Access Compliance Report

Public Rights-of-Way

Intersection ID: N/A	Main Street: SOUTHGROVE_ST	Cross Street: ARDREY_KELL_RD	Location: SW
ADA ID: 1A02AEDD392F	Ramp Type: Directional1	Initial Pass/Fail: Pass	Overall Compliance: No
		Severity Score: 2.5

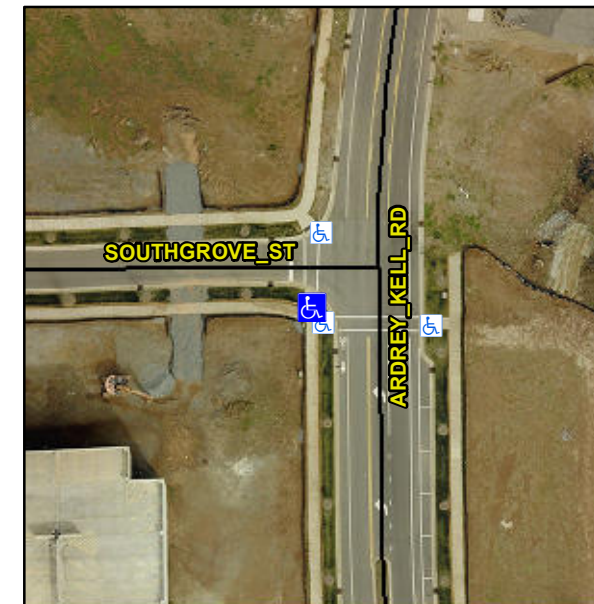
Not Found, R304.2.1, R304.5.2, R305.1.4

Compliance	Description	Data	Compliance	Description	Data
N/A	Ramp Length (in)	74.0	No	Grade Break?	No
Yes	Ramp Width (in)	69.5	N/A	Grade Break Slope (%)	5.6
Yes	Ramp Slope (%)	7.4	N/A	Grade Break XSlope (%)	0.4
Yes	Ramp XSlope (%)	1.8			
Yes	Flare Type LT	N/A	Yes	Flare Type RT	N/A
N/A	Flare Slope LT (%)	N/A	N/A	Flare Slope RT (%)	N/A
N/A	Flare Traversable LT?	No	N/A	Flare Traversable RT?	No
No	Landing Length (in)	44.0	Yes	DWS Provided?	Yes
Yes	Landing Width (in)	70.0	Yes	DWS Contrast?	Yes
Yes	Landing Slope (%)	1.8	Yes	DWS Length (in)	24.0
Yes	Landing X Slope (%)	1.3	No	DWS Full Width?	No
N/A	Landing Curb? (Y/N)	N/A	Yes	DWS Offset LT (in)	0.0
N/A	Shared Landing?	No	Yes	DWS Offset RT (in)	38.0
Yes	Gutter Ponding?	No	Yes	Gutter Slope (%)	4.1
Yes	Gutter Lip Ht (in)	0.0	Yes	Gutter X Slope (%)	0.1
N/A	Painted X Walk1?	Yes		Road Slope (%)	2.8
	X Walk 1 Direction	To NW		Road X Slope (%)	0.8
	X Walk 1 Width (in)	70.0		Clear Space?	Yes

Remove & Replace Entire Ramp.
